Louisville Revitalization Commission

SUBJECT: DOWNTOWN FRONT AND CENTER UPDATE

City Staff will provide an update to the LRC on the revisions and additions made to the Downtown Front & Center concept plan based on LRC feedback provided at the March 25th meeting. The project team has developed a full range of improvement options that can be selected and prioritized to fit within the available project budget in the attached revised concept plans. Presented below is a summary of major comments provided by LRC at the previous meeting and via email and an explanation of how those comments have been incorporated into the revised concept plans:

CITY OF LOUISVILLE FRONT & CENTER PROJECT REVISED CONCEPT PLANS

LIGHTING ARRANGEMENT CONSTRAINTS:

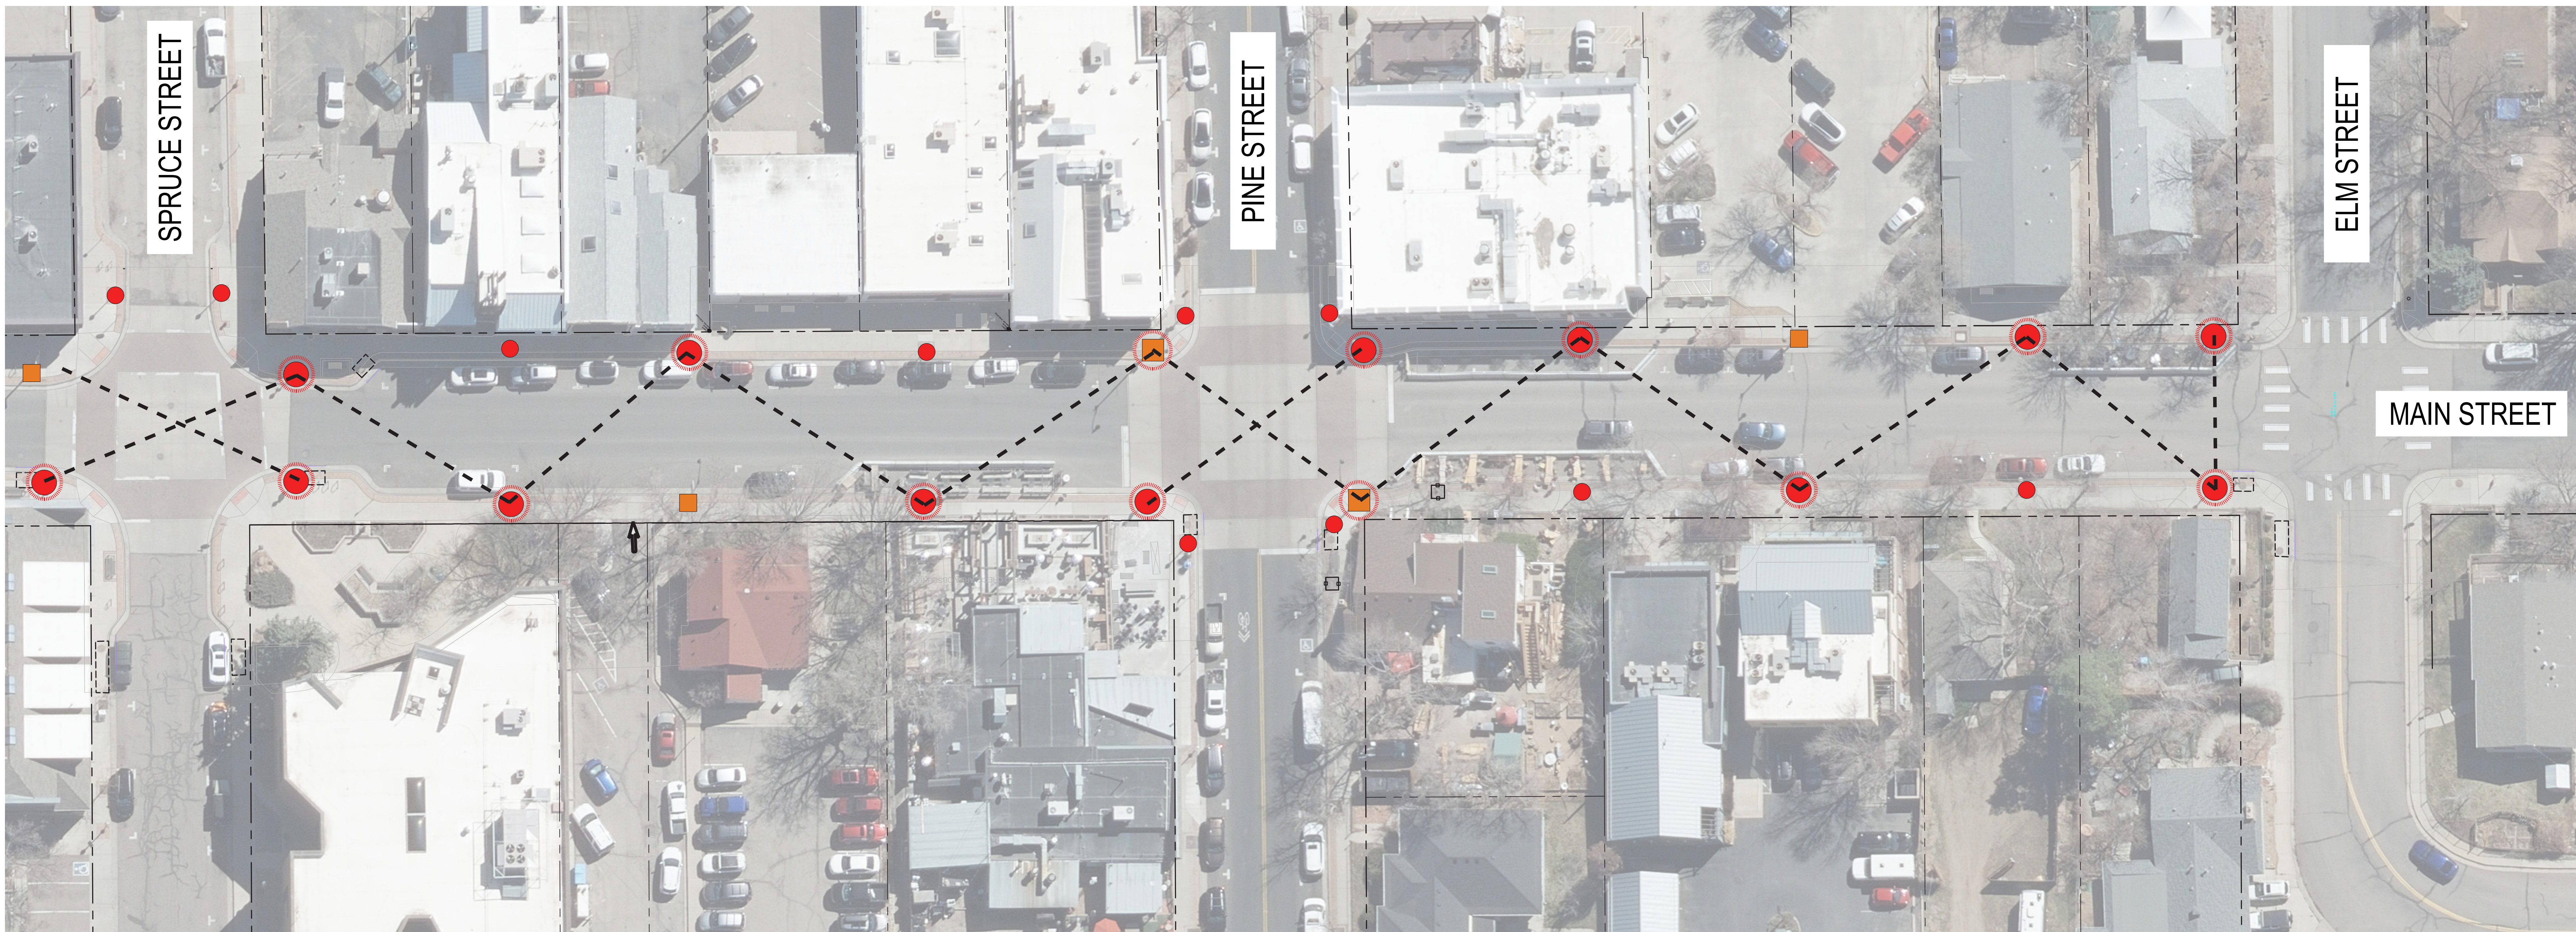
- Provide lighting options extending from South Street to Elm Street.
 - *Two lighting options have been provided for the Main Street corridor, Alternatives A & B. Both alternatives extend from South Street to Elm Street and include the removal and replacement of Xcel-owned poles as required. The City would take ownership of the new the poles. Anticipated costs for Alternative A range from \$1,227,500 to \$1,352,000. Anticipated costs for Alternative B range from \$912,500 to \$1,037,000. Unfortunately, a range of costs must be provided as design must progress further to better understand the electrical distribution costs. Note that these costs do not include intersection lighting costs. Intersection lighting costs are*

anticipated to add an additional \$234,000 - \$334,000 per intersection (or \$1,170,000 - \$1,670,000 for all five intersections).

INTERSECTION IMPROVEMENTS

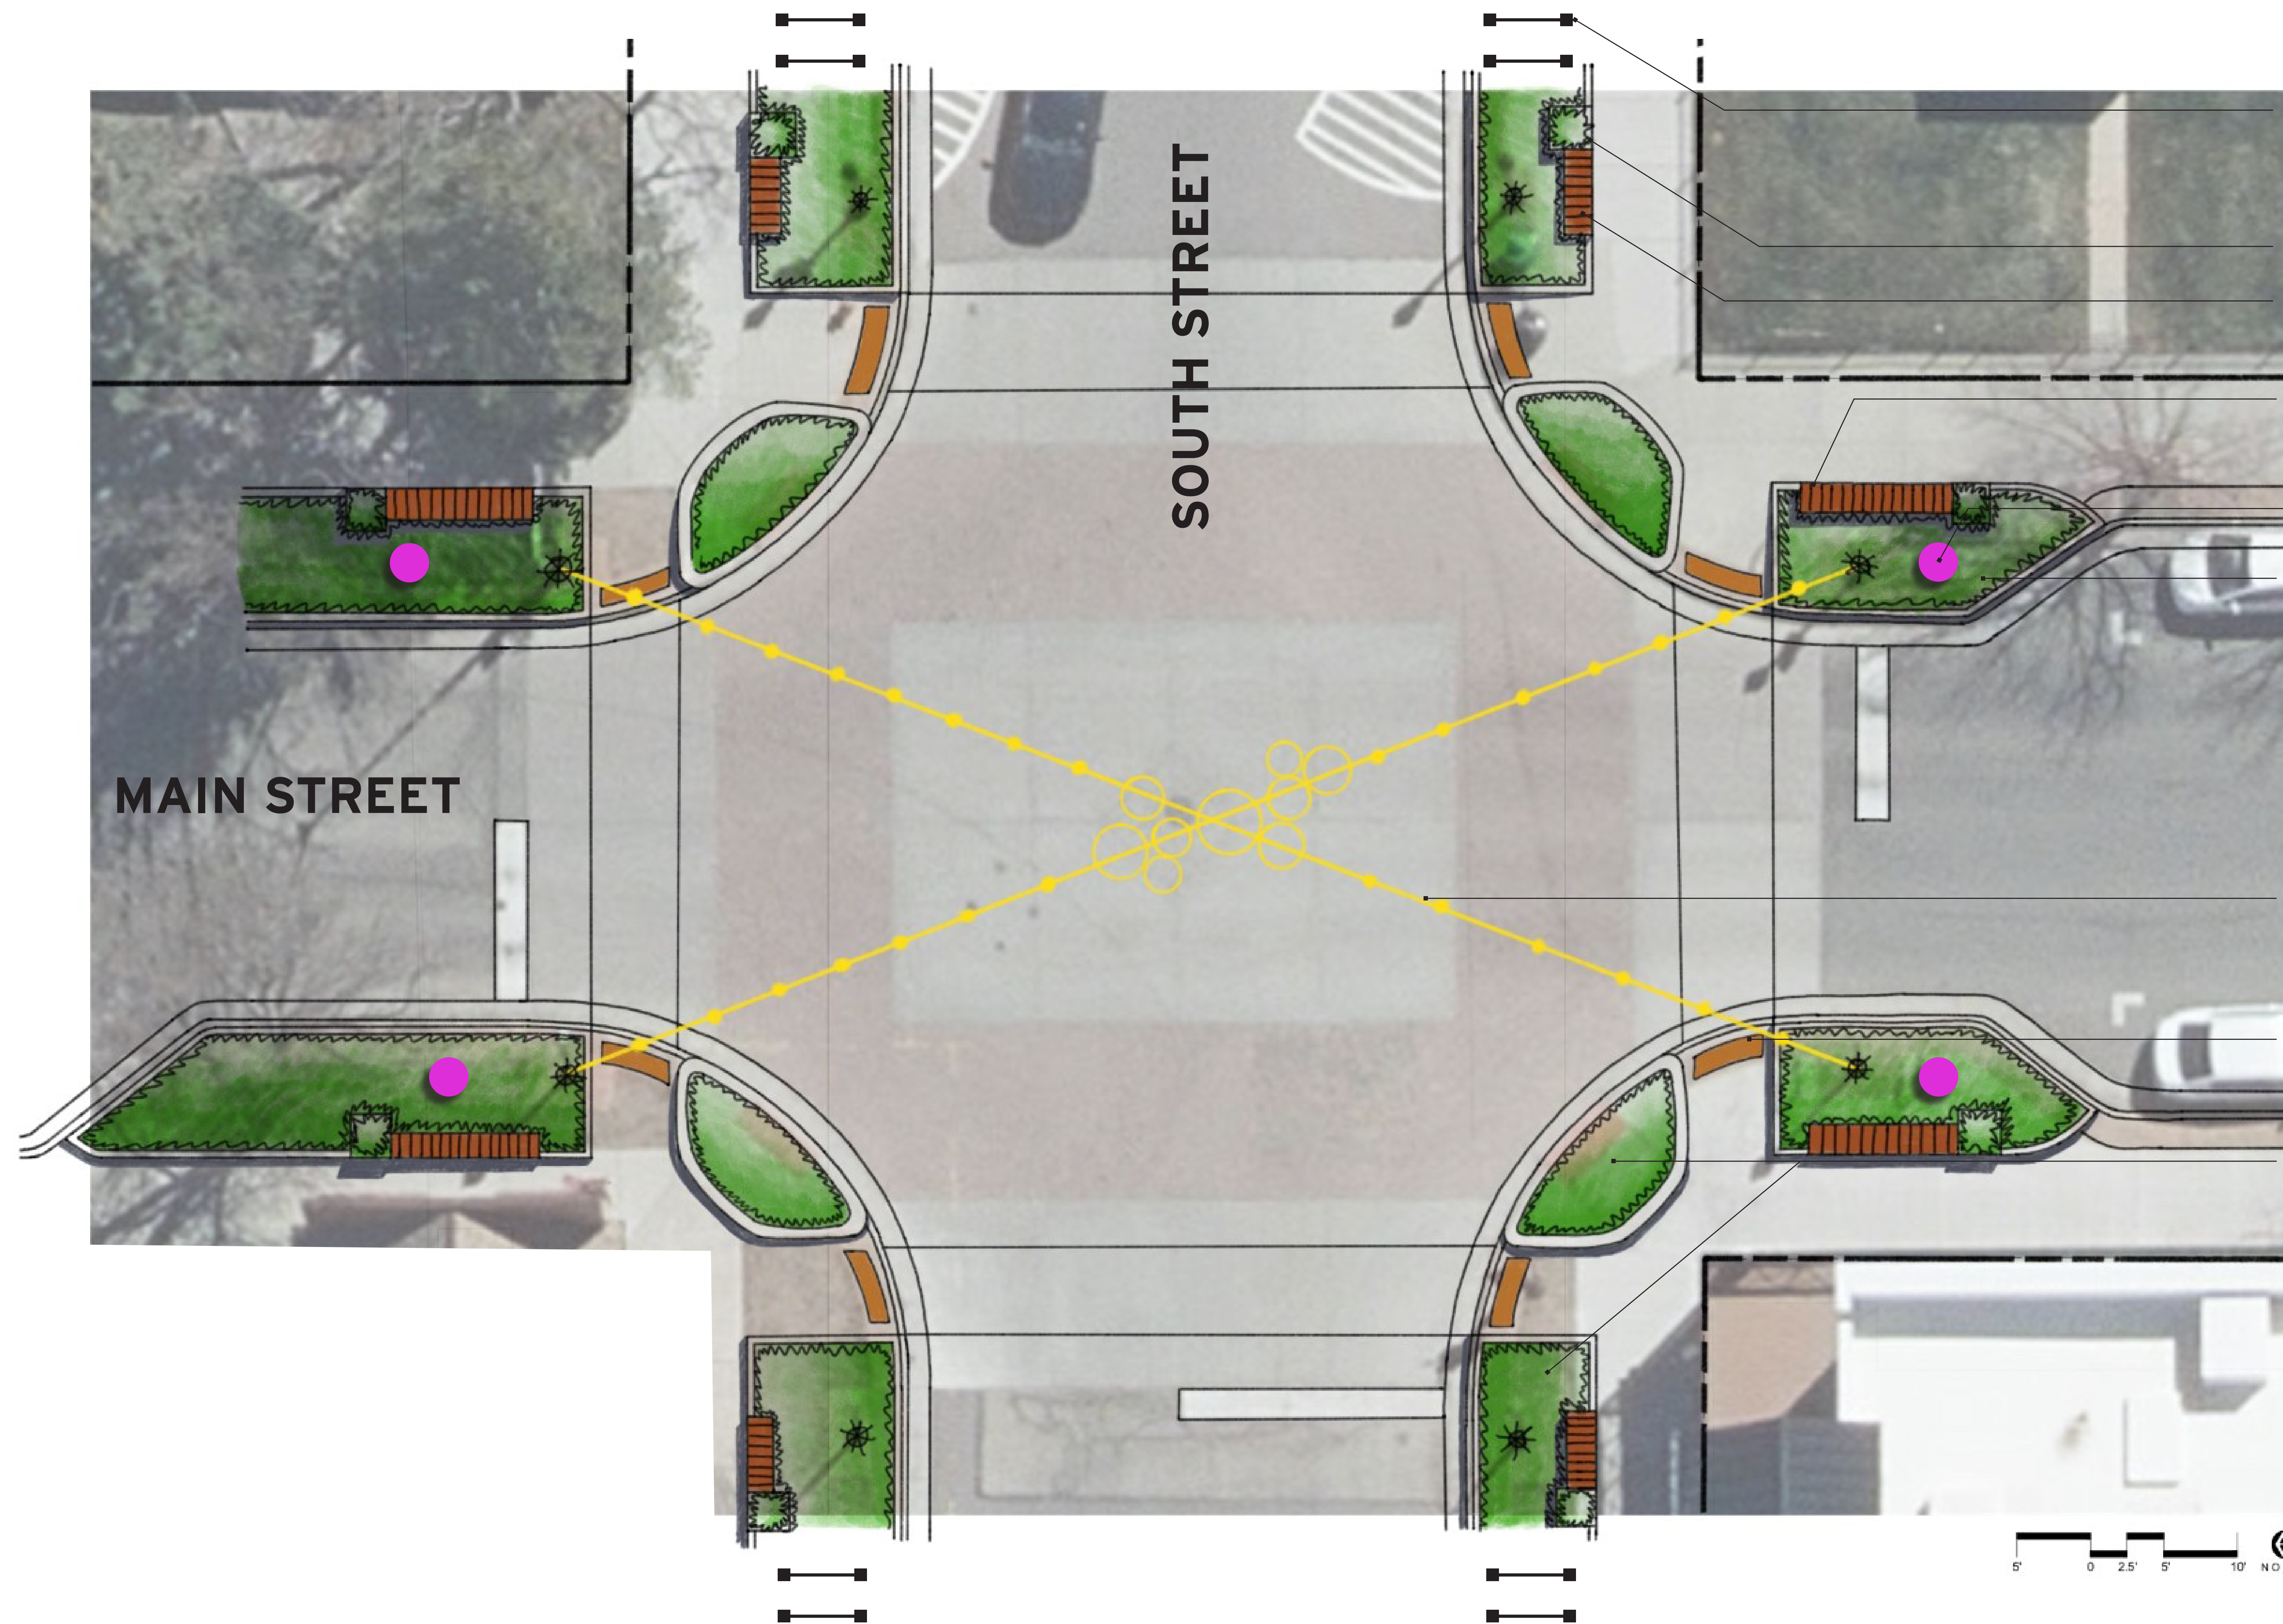
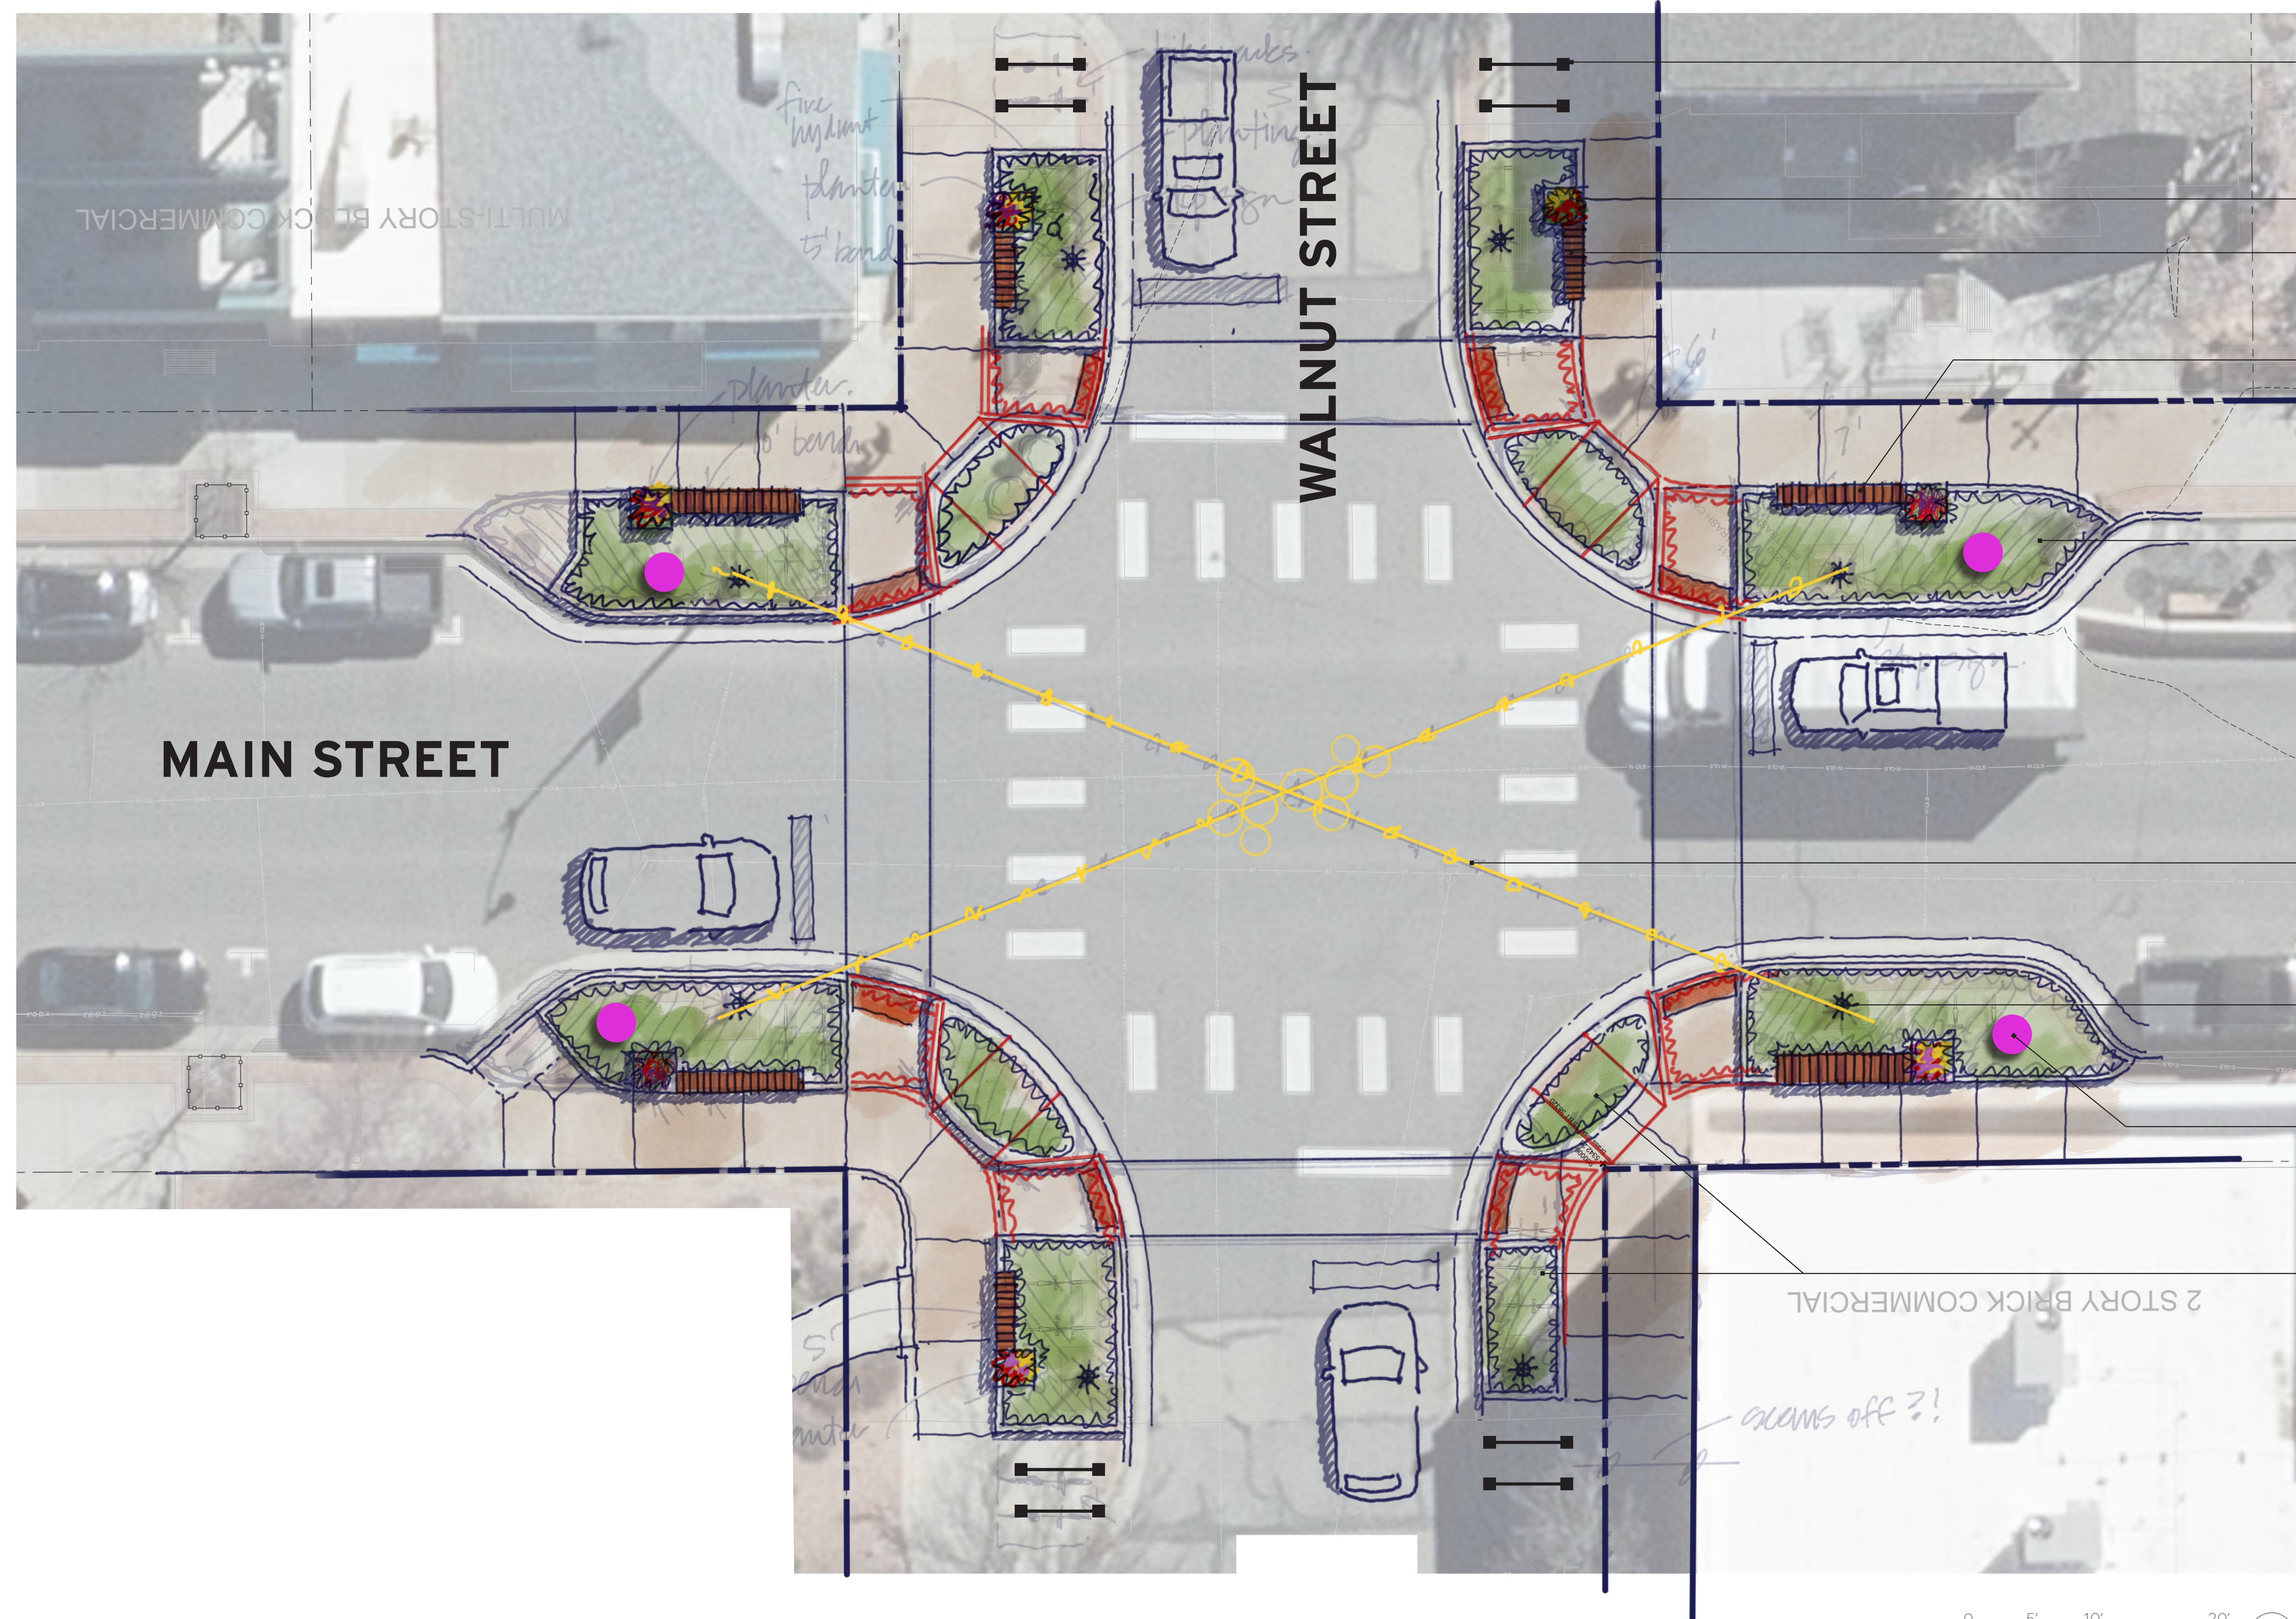
- Incorporate trees, landscaping, in-ground planters, and planter pot options at intersections.
 - *Landscaping options including in-ground planting and planters have been included for five (5) intersections along Main Street: South Street, Walnut Street, Spruce Street, Pine Street, and Elm Street. Plantings include deciduous shrubs, ornamentals, and perennials. Benches have also been provided at intersections. Concept plans for each intersection are provided in the conceptual design package. The estimated cost for these improvements is \$228,500 per intersection, or \$1,142,500 for all five (5) intersections. This does not include the costs for intersection lighting or street trees.*

- Provide bench seating near intersections.
 - *Bench seating has been included with the updated intersection landscaping plans and is included in the costs above in bullet #1. Additionally, an inventory of benches has been taken along the Main Street corridor for informational purposes and further planning.*
